Subject: 124 – 126 Bull Street, Newcastle West (MA2024/00381)

I am writing to the City of Newcastle (CN) regarding modification application MA2024/00381 at 124-136 Bull Street, Newcastle West and the Request for Additional Information (RFI) received 29 May 2025 and 19 June 2025. The following information is provided in response to the requests.

Figure 1 2018 Site Massing recognising that the design responded to the parameters of the site (Source: 2018 Pre-DA meeting)

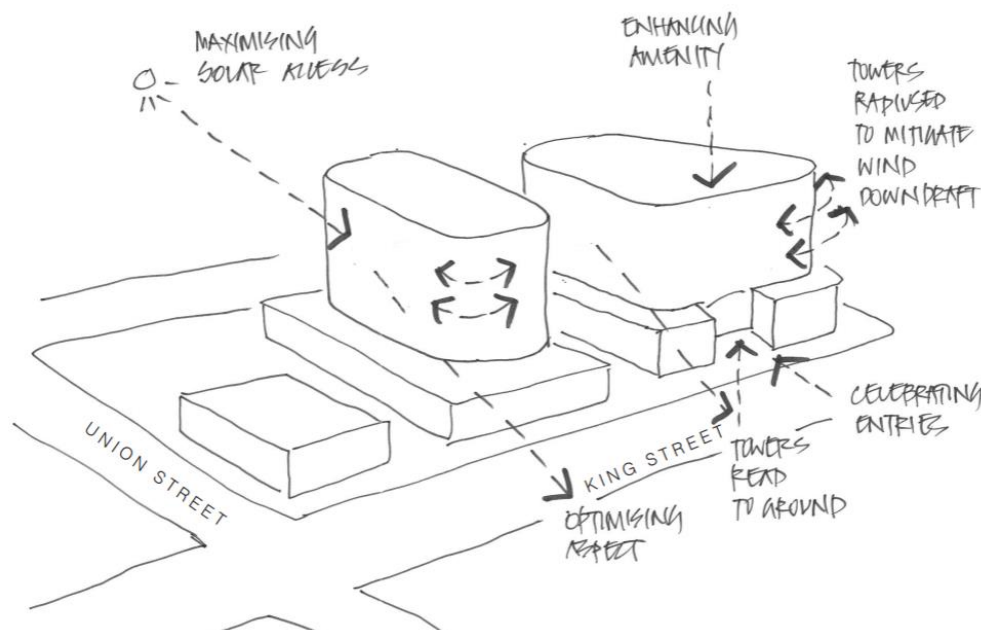
- *The HCCRPP has stated the site is unconstrained and has limited development scale proximate to it. This comment is to be addressed.*
- *Details of the original site arrangement analysis and how the proposal came to be the optimal scheme for the site is required.*

Figure 1 below represents that the original site massing was responsive to the parameters of the site presented at the pre-DA meeting held in 2018. This diagram illustrates how architectural massing at concept design stage considered orientation to local streets, the relationship of the towers to street level experience, enhancement of amenity, protection from winds and solar access.

The concept for the site was informed by the existing surrounding parameters. The relationship between King St and the long eastern site boundary to the Wests Club is perpendicular. This sets up a logical orthogonal master plan response of two towers with orthogonal relationships to King St and east boundary. These were proposed in the original DA, first Modification and current modification and are consistent with the existing streetscape and context of built form. A through site link aligns with the eastern boundary and includes an important memorial walk honouring the victims of the 1989 earthquake. East and west facing living spaces have been located hard up to the façade line to optimise sunlight penetration. Their balconies have been over sized and hinged open to better capture northern views and sunlight and are a design feature of the proposal.

If the correct solar angle had been known at the time the approved DA was designed, the approach could have been different. The towers may have been taken off the orthogonal and rotated the eastern facades up to 10 to 15% anti clockwise off alignment with the eastern boundary to optimise solar penetration into apartments. However, the clear orthogonal relationship between street, podium and tower would be compromised. It could also lead to an awkward alignment of structure between offset towers and podium levels, which would remain orthogonal.

Another scenario could have been to step the east tower façades in towards King St to further expose apartments to sunlight. This would produce a ziggurat plan form and a complex building volume. In both cases the balconies may have been drawn in flush to the east and west facades to optimise solar penetration. The amenity of harbour views and additional daylight on these balconies would be lost in this case.

Figure 2 Sun angle analysis identifying the previously documented sun-eye view and actual sun-eye view (Source: Fender Katsalidis)

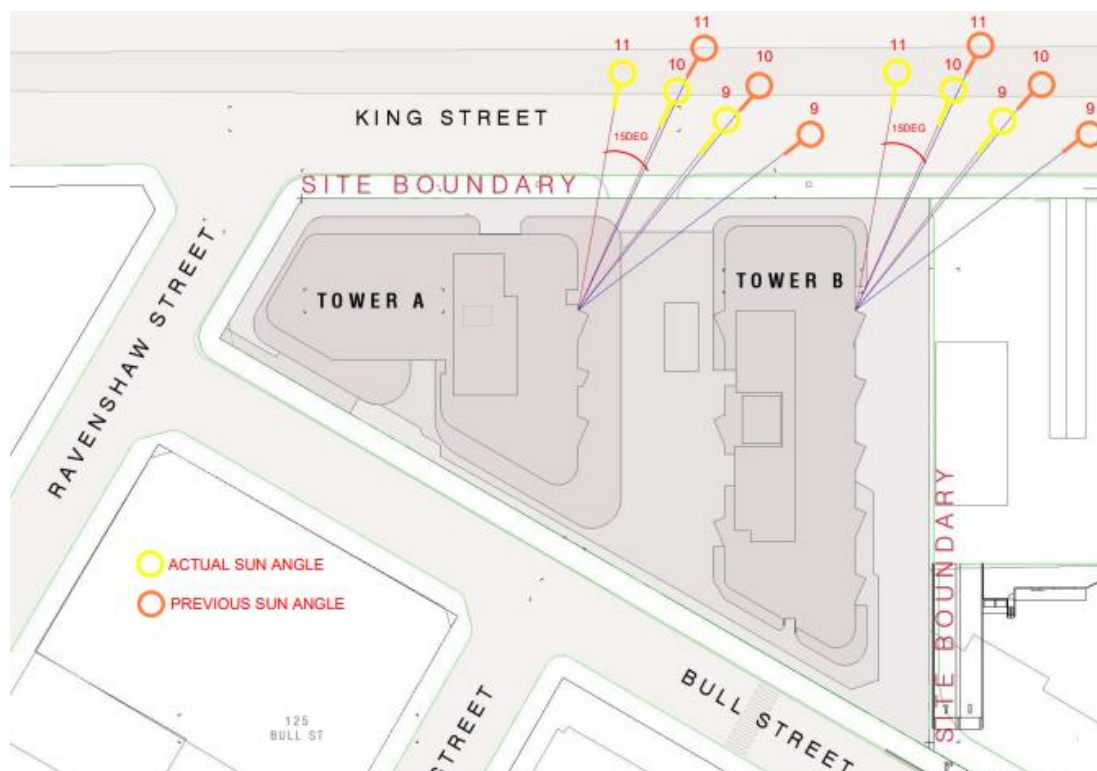
In May 2025 when converting sun-eye view diagrams to REVIT in response to a CN Request for Additional Information dated 6th March 2025, it was discovered that the previously issued sun-eye view diagrams, created in ArchiCAD were not matching the new REVIT diagrams. A forensic review of the ArchiCAD files dating back to 2018, and the original DA Approval, revealed that the previously documented sun-eye view

was set up incorrectly. The resultant error is a 15 degree shift in the angle of the sun, rotating anti-clockwise around the site, therefore reducing the available morning sun by approximately 1 hour (see Figure 2 below).

Figure 3 Proposed design adjustments to the AC plant to improve sunlight access to the balcony and habitable rooms

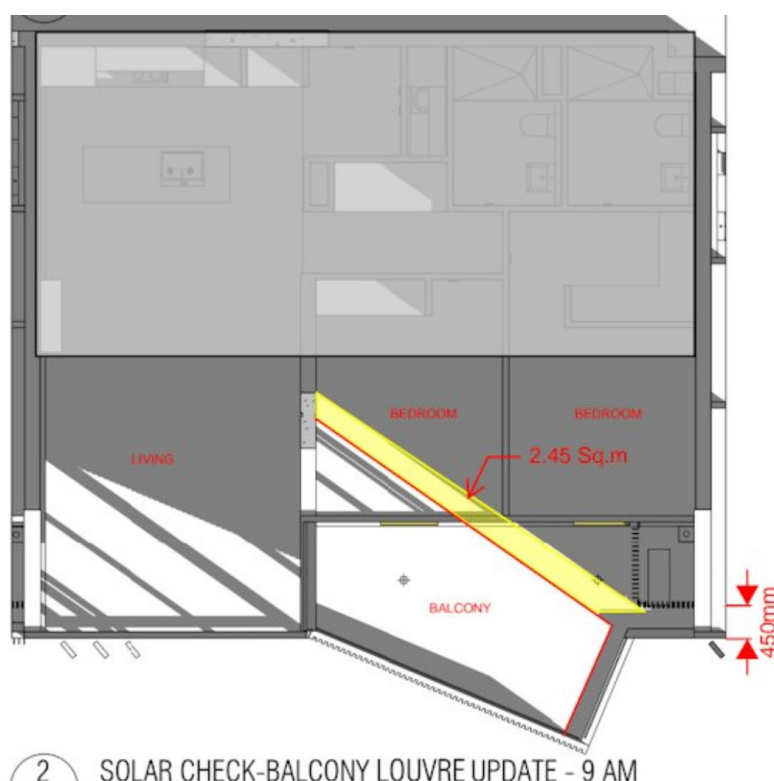
The additional information documentation package on the 12 May 2025 identified adjustments that could be made to the balcony AC plant enclosures (see Figure 2 below). The proposed adjustments were reflected within the draft conditions of consent proposed by CN.

Details of these adjustments have been further detailed on Page 17 of Appendix 3. Further analysis has been undertaken of the adjustment to the balcony AC plant enclosures demonstrating how solar access to balconies and bedrooms will be improved. This adjustment has not been reflected within the Table 1 statistics above and is not anticipated to change any of the proposed statistics.

Figure 4 Rooftop form of Wests building in Original DA (Source: Appendix 2)

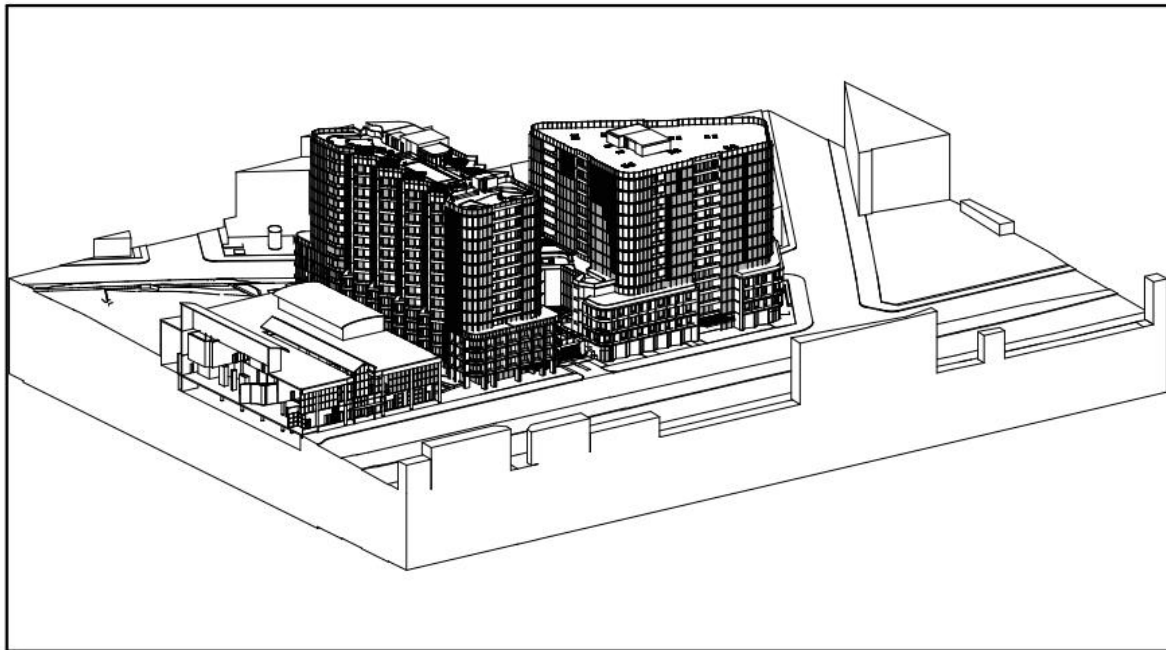
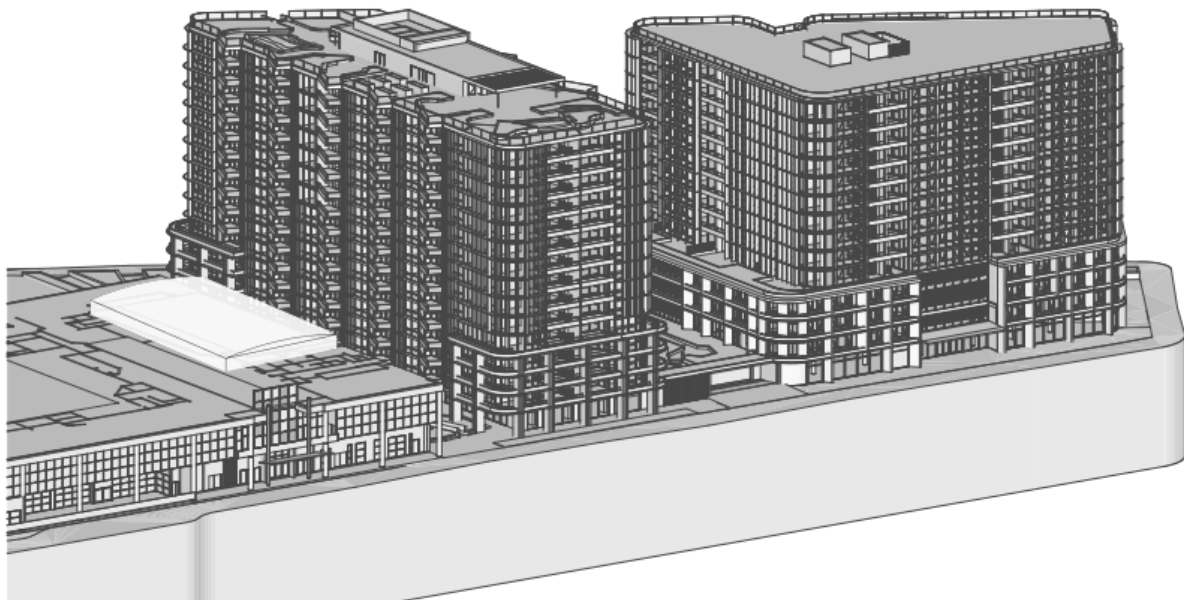
2. *The 'VIEW FROM SUN DIAGRAM' drawings provided for Mod 1 and the current modification application omit the built form of the uppermost level of the neighbouring development to the east (no. 309 King Street, Wests Club). As a result, Levels 1 and 2 of the apartments on the eastern façade of Tower B cannot be properly assessed and it is considered that some of these apartments would not receive solar in the early morning period.*

The original DA contained detailed modelling of the adjoining Wests building. The First Modification and Current Modification models were based on current survey information that provided a very simplistic massing of the building. The raised roof element on the West building was not included within this simplistic modelling. The raised roof elemental would have had a very limited impact on the assessment of the First Modification and the Current Modification. However, it should be noted that apartments on the lower levels of the Tower B east facade have never been assessed as having 2 hours sunlight on June 21. Therefore, there is no impact on the compliance percentage as a result of this issue. An amended outline for the Wests roof line has been added to the First Modification and Current Modification sun eye view diagrams so that the area of impact can be identified. The sun eye diagrams within Appendix 2 to reflect the correct modelling of the Wests building and are demonstrated within the figures below.

Figure 6 First modification (left) showing perpendicular louvre design. Current modification (right) showing updated louvre design.

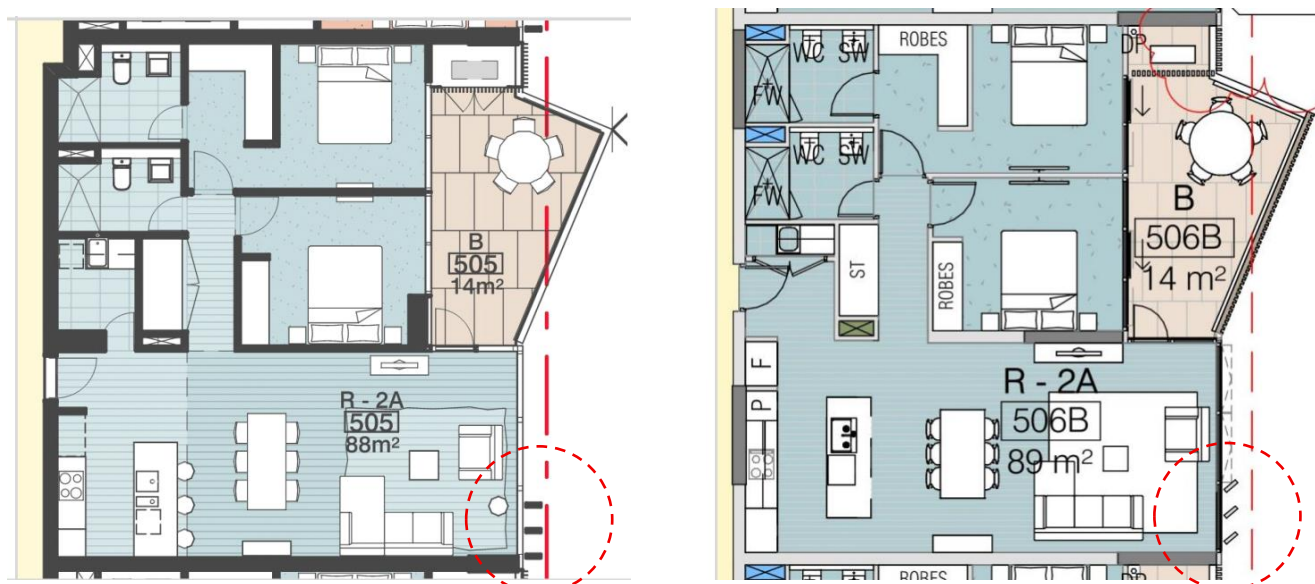
3. FK identifies the Tower B east facing apartments as receiving 1hr 30mins solar access to the living rooms (see pages 14-16 of Appendix 2) under Mod 1. However, these same apartments are identified as receiving 1hr 45mins solar access to the living rooms under the current modification. It is noted the additional solar analysis provided on pages 11 and 12 of Appendix 3 to demonstrate that the Tower B east facing apartments generally receive 1hr 45mins solar access to the living rooms (the expecting being the 1-bedroom apartments at Level 8 and above) in accordance with the '1sqm

@ 1 meter above FFL' criteria, is accepted by CN. As such, it is unclear why the calculations for the Mod 1 have identified these apartments as receiving only 1hr 30mins solar access, rather than the 1hr 45mins.

This discrepancy is due to a change in the angle and spacing of privacy louvres to these apartments. In the Current Modification, privacy louvres were changed from being perpendicular to the façade, to being angled towards the sun. Additionally, spacing between the louvres was increased. Both these design changes allowed more sunlight to access apartments between the louvres.
